November 1, 2023

**WHITE PLAINS CITY SCHOOL DISTRICT
AC AND VENTILATION UPGRADES AT
MAMARONECK AVENUE ELEMENTARY SCHOOL
SED Control Number: 66-22-00-01-0-010-017**

**CONTRACT H- HVAC WORK
CONTRACT E - ELECTRICAL WORK**

DRAWING No.
MD110.00

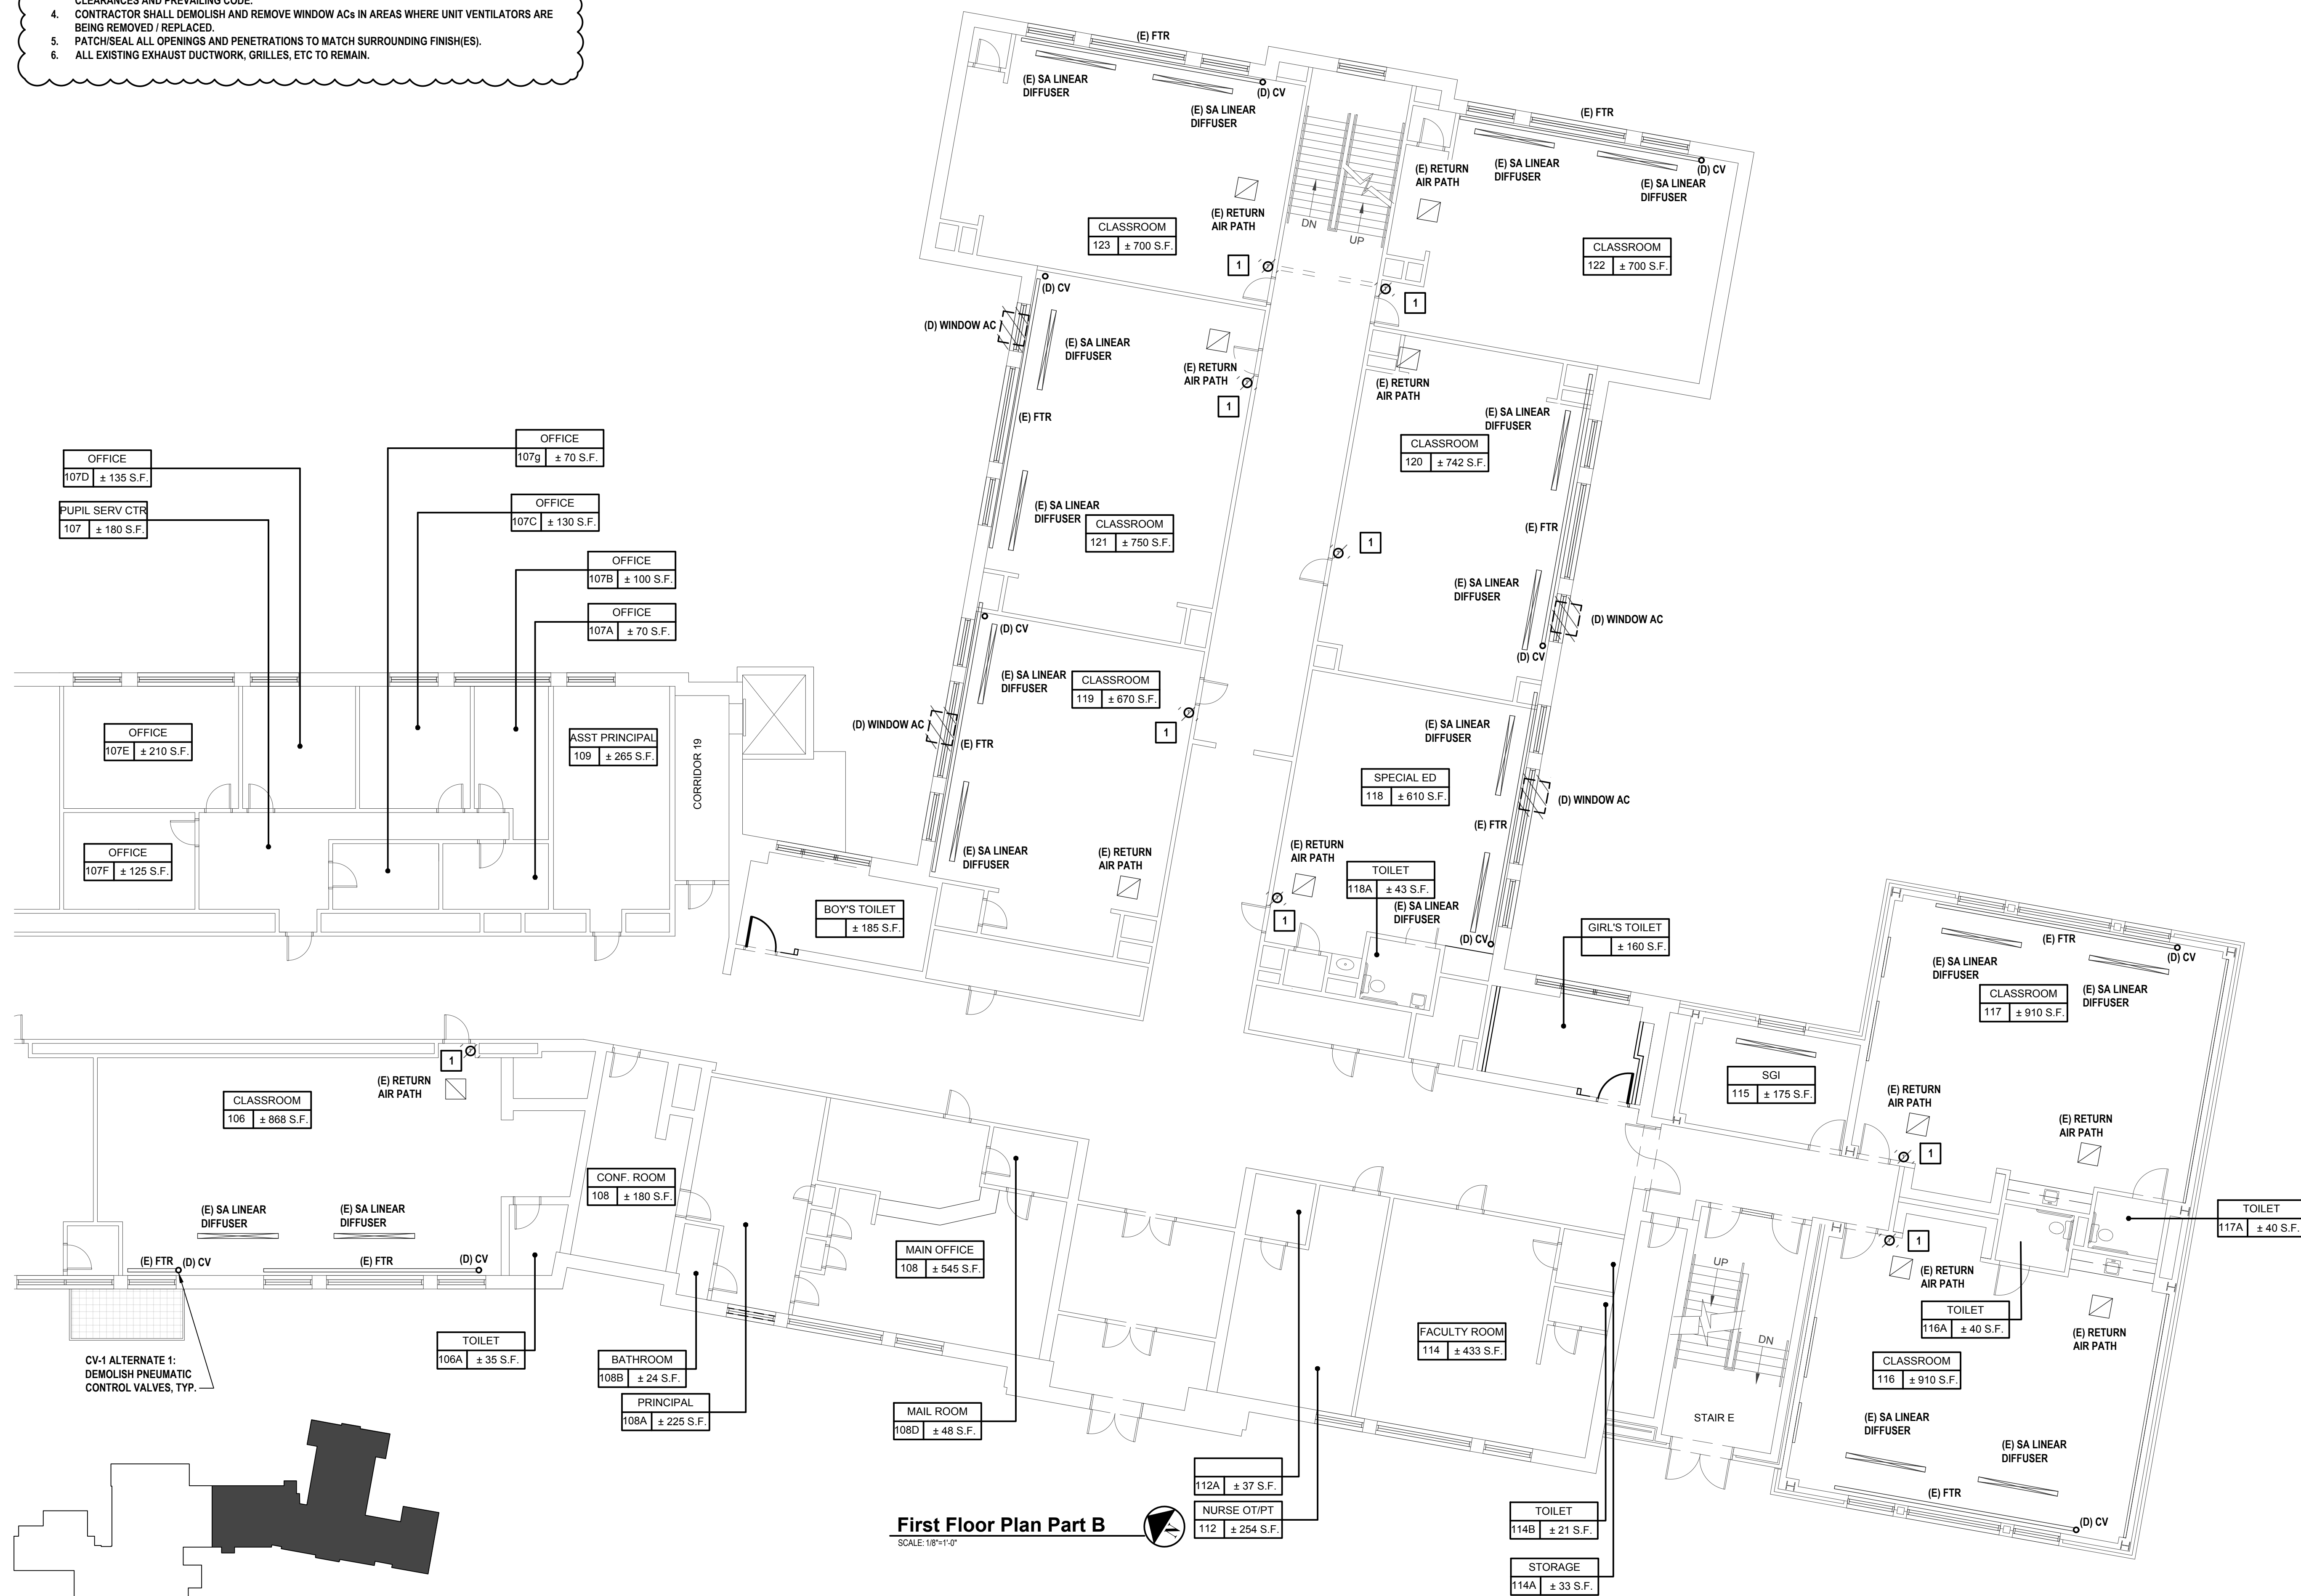
8. REMOVE DRAWING MD110.00 MECHANICAL FIRST FLOOR PLAN PART A AND REPLACE WITH REVISED DRAWING MD110.00 MECHANICAL FIRST FLOOR PLAN PART A. attached herewith. Please note that this drawing has been revised to clarify scope for the chase work, and mechanical work.

1 THERMOSTAT TO BE DEMOLISHED AS PART OF ADD ALT 1. SEE SHEET M001.
THERMOSTAT TO REMAIN AS PART OF BASE SCOPE

MD120.00

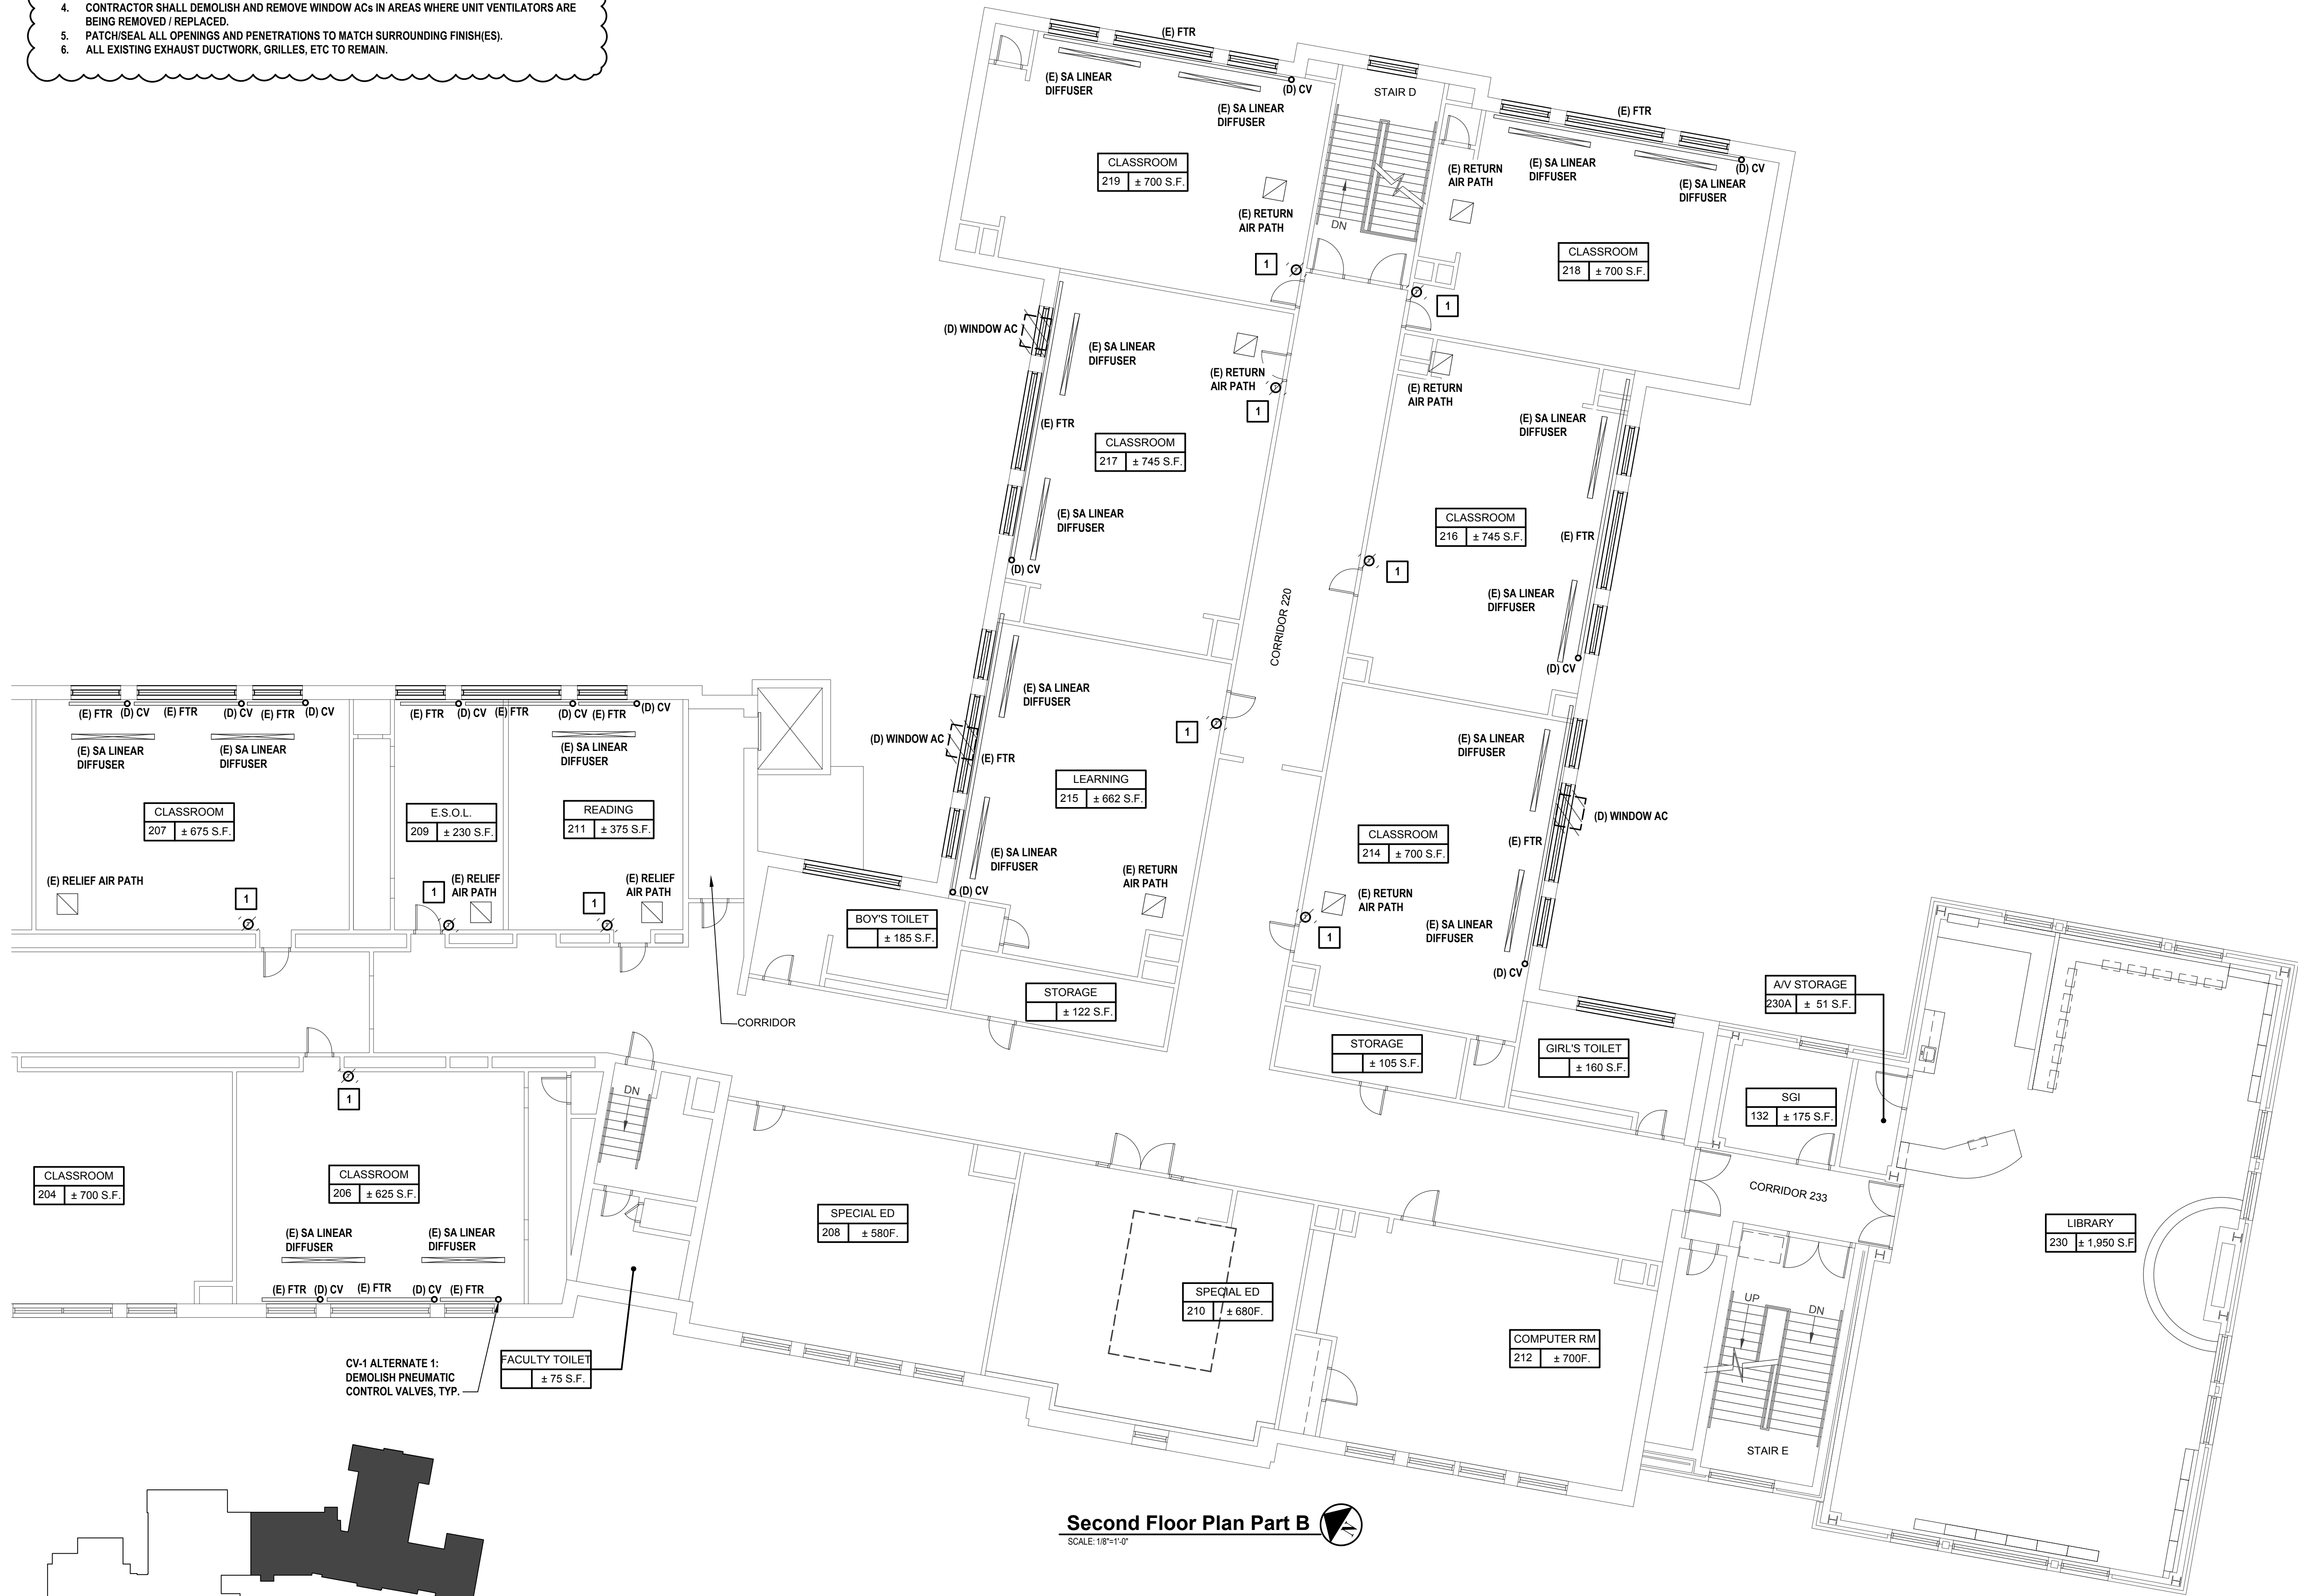
10. REMOVE DRAWING MD120.00 MECHANICAL SECOND FLOOR PART A AND REPLACE WITH REVISED DRAWING MD120.00 MECHANICAL SECOND FLOOR PART A. attached herewith. Please note that this drawing has been revised to clarify scope for the chase work, and mechanical work.

- 1 THERMOSTAT TO BE DEMOLISHED AS PART OF ADD ALT 1. SEE SHEET M001.
THERMOSTAT TO REMAIN AS PART OF BASE SCOPE

M101.00

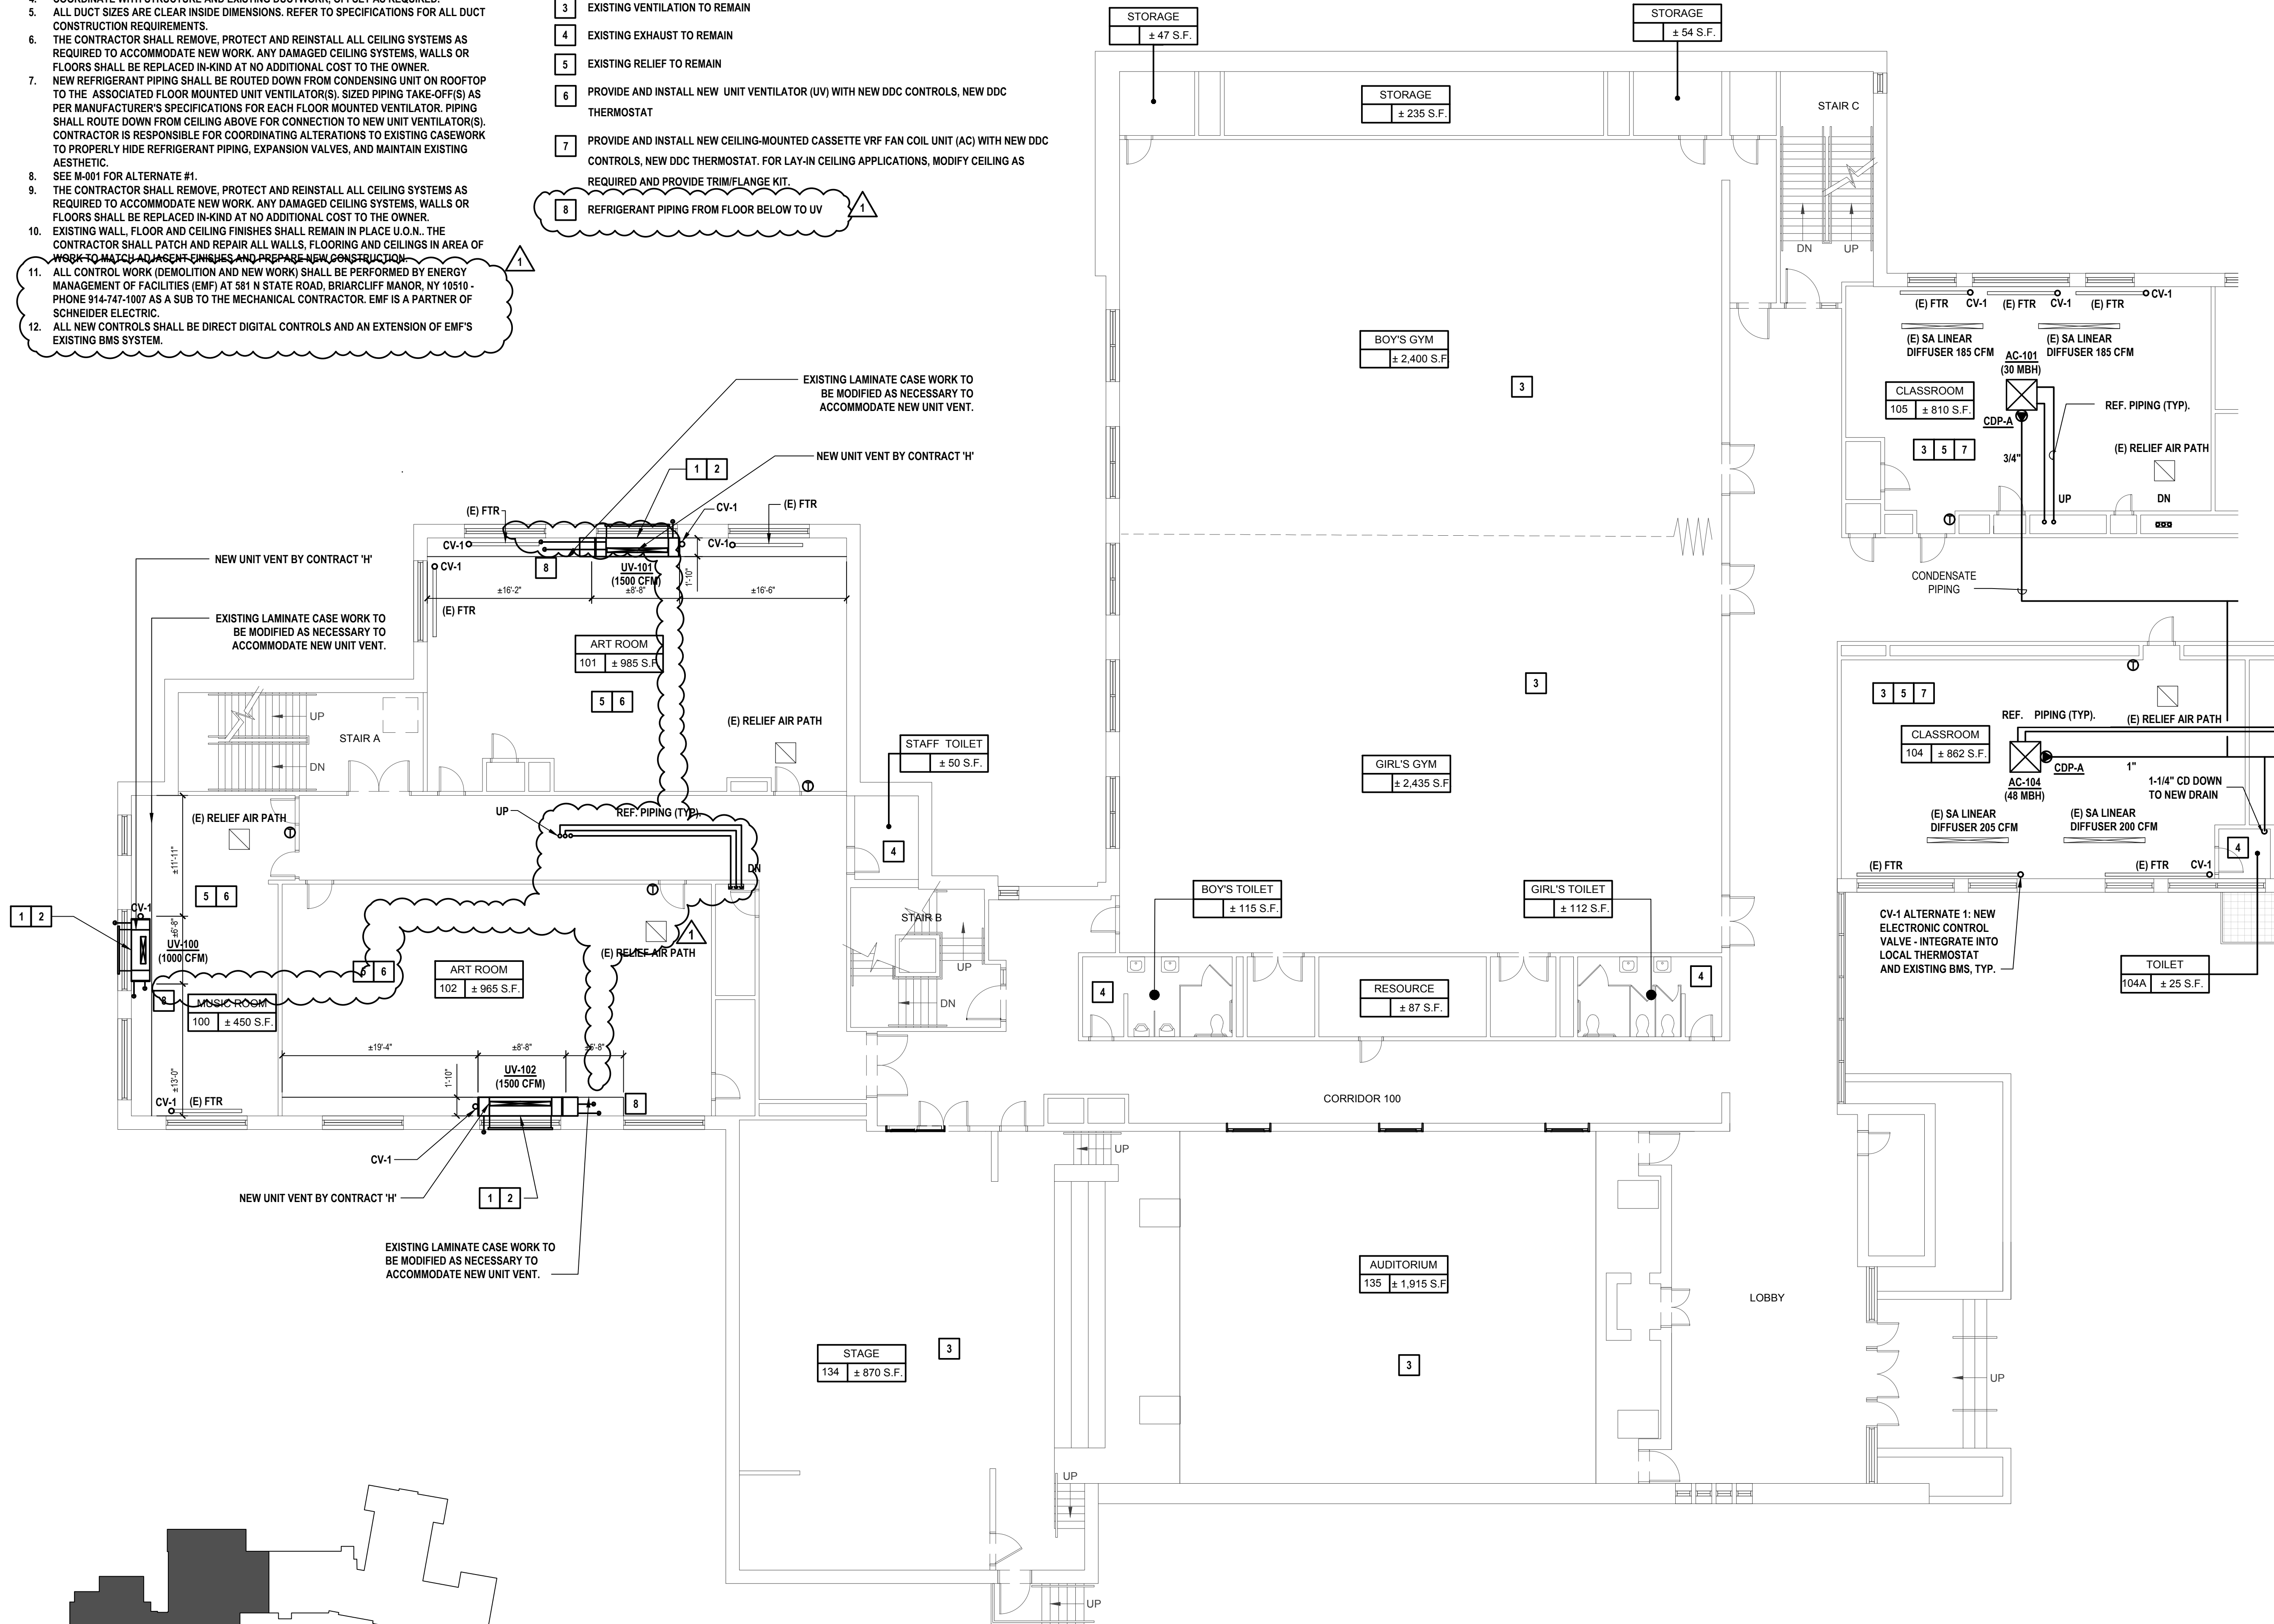
3. REMOVE DRAWING M101.00 MECHANICAL GROUND FLOOR PLAN PART B AND REPLACE WITH REVISED DRAWING M101.00 MECHANICAL GROUND FLOOR PLAN PART B attached herewith. Please note that this drawing has been revised to clarify scope for the chase work, and mechanical work.
